DEPARTMENT OF TRANSPORTATION

49 CFR Part 571

Tire Safety Information

ACTION: Final rule; response to petitions for reconsideration; technical amendment.

Figure 1

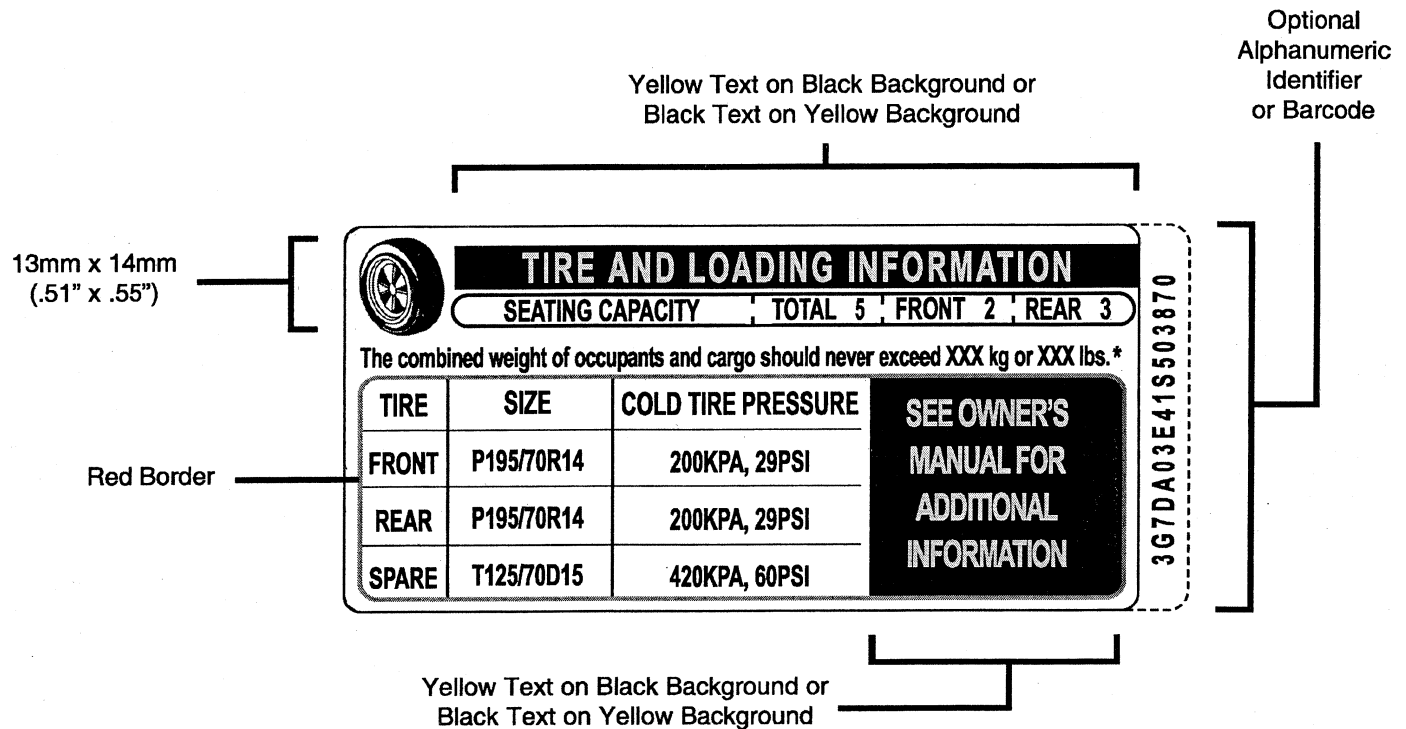
■ 2. Section 571.110 is amended by revising S4.2.2; S4.3(c), (d), (h) and (i); the example in the last paragraph of S4.3.3; S4.4.2 introductory text; and Figures 1 and 2 at the end of Section 571.110, to read as follows:

(h) At the manufacturer's option, identifying information provided in any alphanumeric and or barcode form, located vertically, along the right edge or the left edge of the placard or the label, or horizontally, along the bottom edge of the placard or the label; and

(i) At the manufacturer's option, the load range identification symbol, load index, and speed rating, located immediately to the right of the tire size designation listed in accordance with S4.3(d) above.
